City of Portland, Maine – Building or Use Permit Application 38th Congress Street, 04101, Tel: (207) 874-8703, FAX: 874-8716

DATE: 29 Aug 1998 ADDRESS: 18 Copley Woods Circle Lot #21
 REASON FOR PERMIT: To Construct a single family dwelling /A/ garage
 BUILDING OWNER: KTO Builders
 CONTRACTOR: " "
 PERMIT APPLICANT: " "
 USE GROUP R-3 BOCA 1996 CONSTRUCTION TYPE 5B

**CITY OF PORTLAND, ME
BOCA 1996 Plan Review Record
One and Two Family Dwelling**

PLAN
 LOT #21
 COPLEY WOODS
 PORTLAND, MAINE

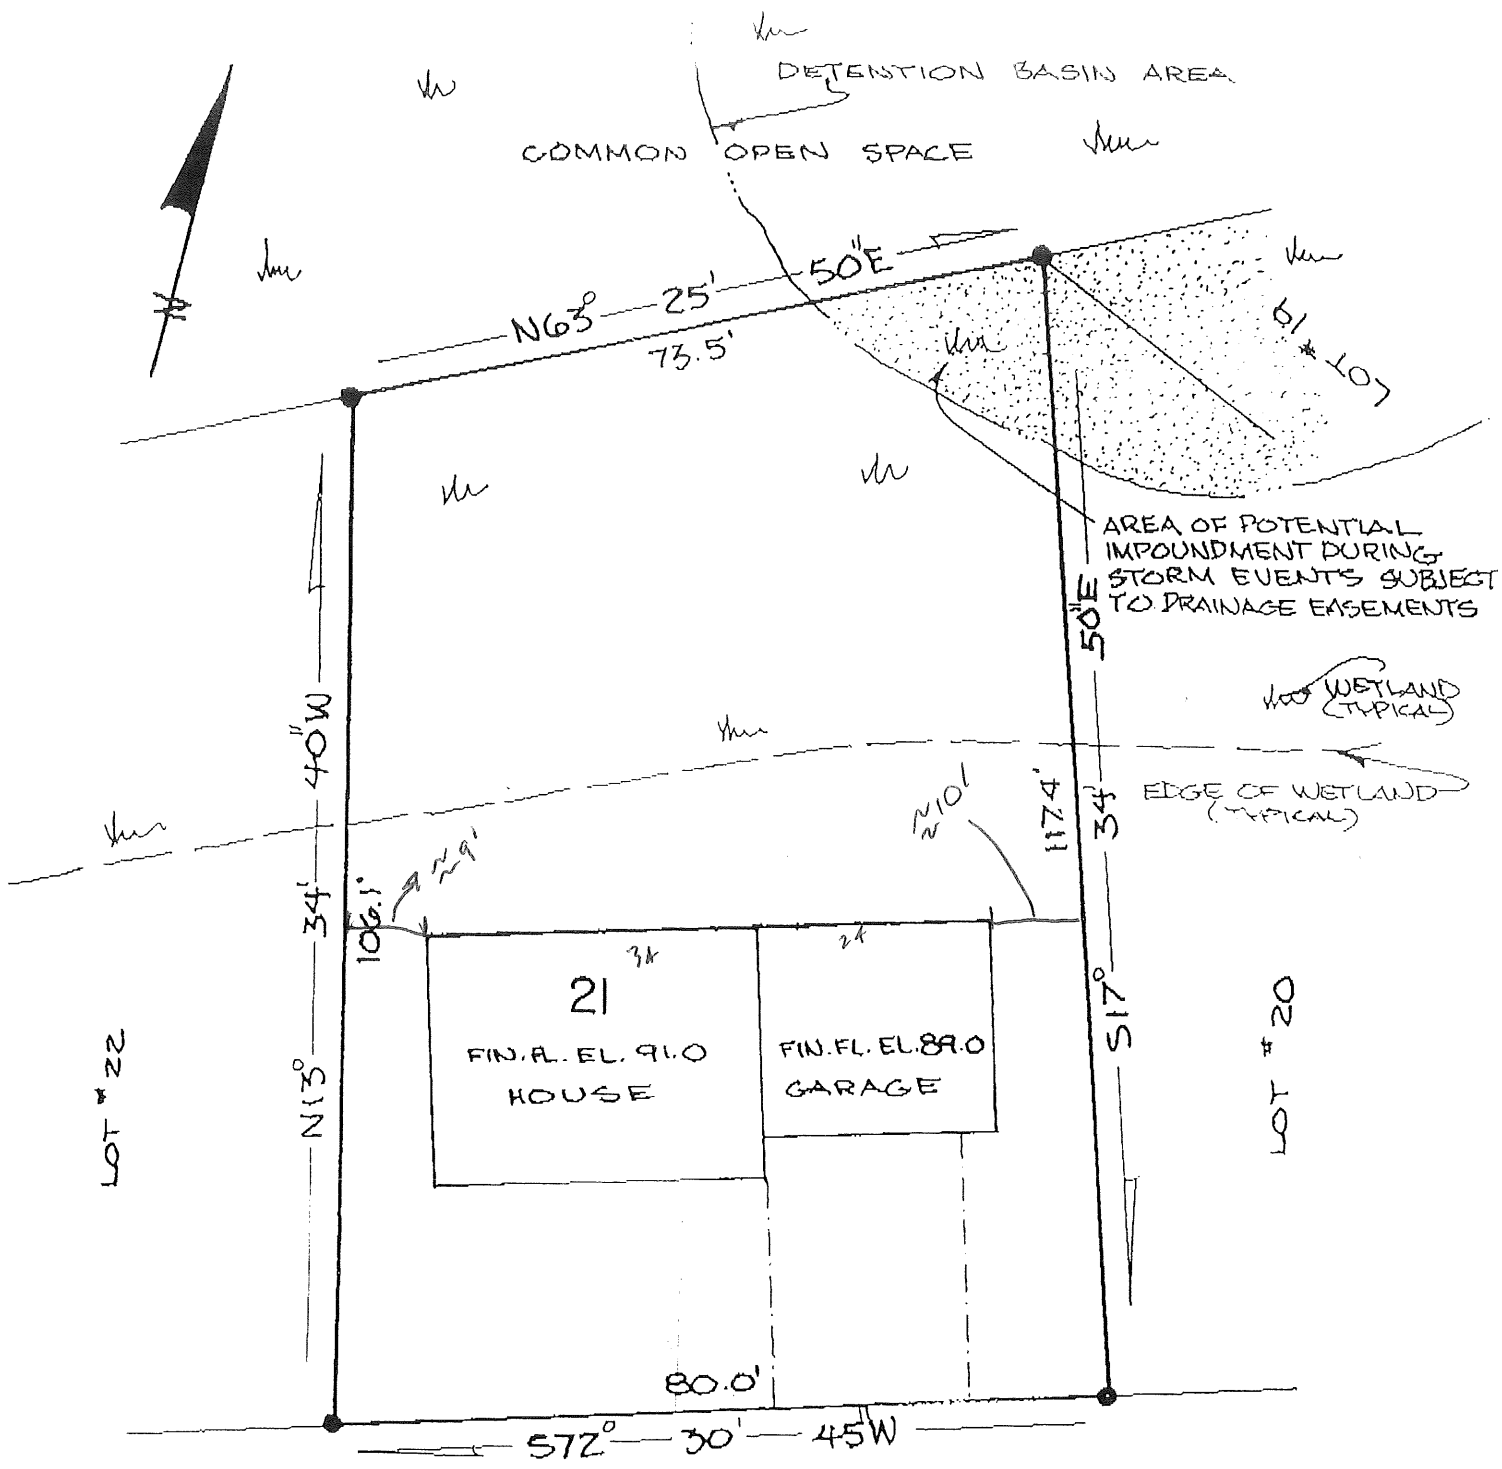
? ~~Site Plan~~
 See Revised
 Site Plan

LOT GRADING & EROSION CONTROL
 for
 COPLEY WOODS - KTO BUILDERS
 LOT 21
 AUGUST 7, 1998

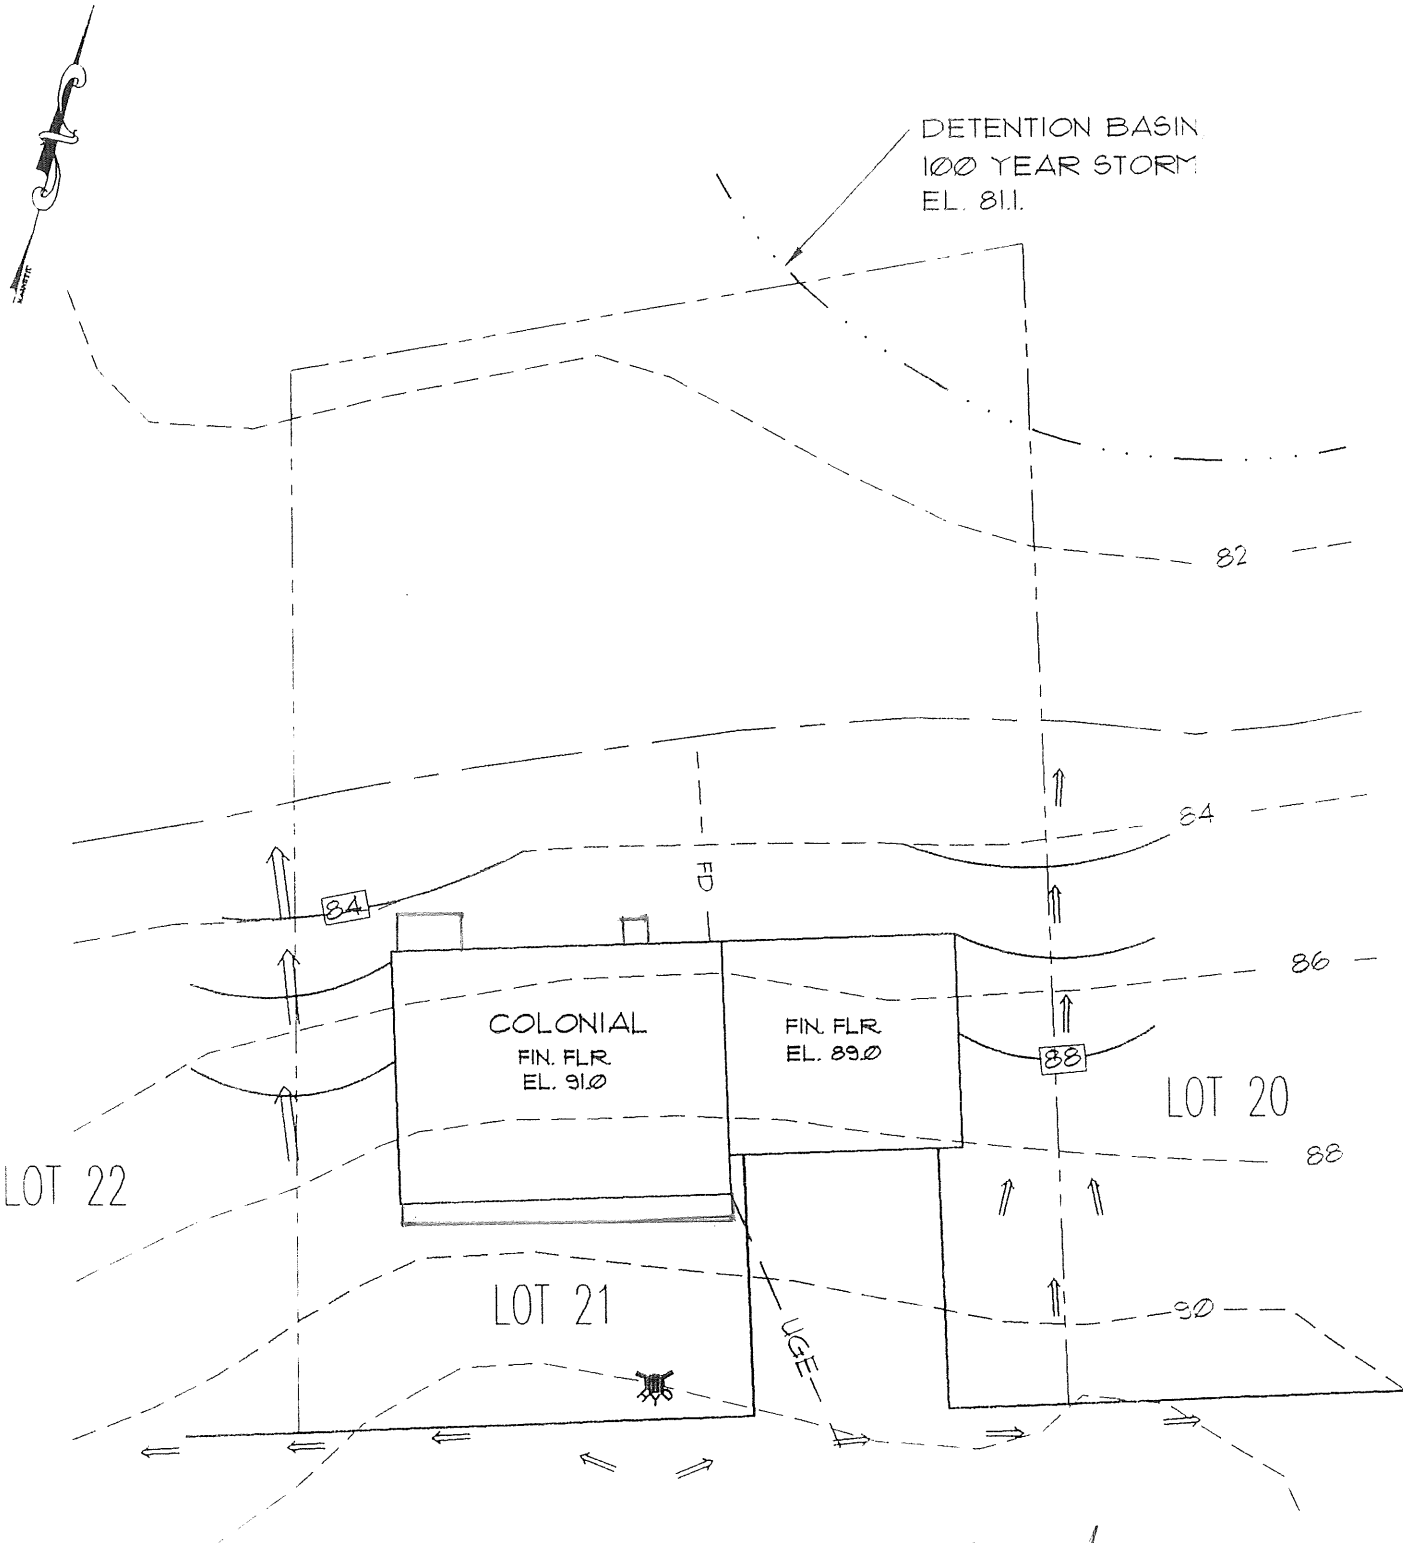
revised
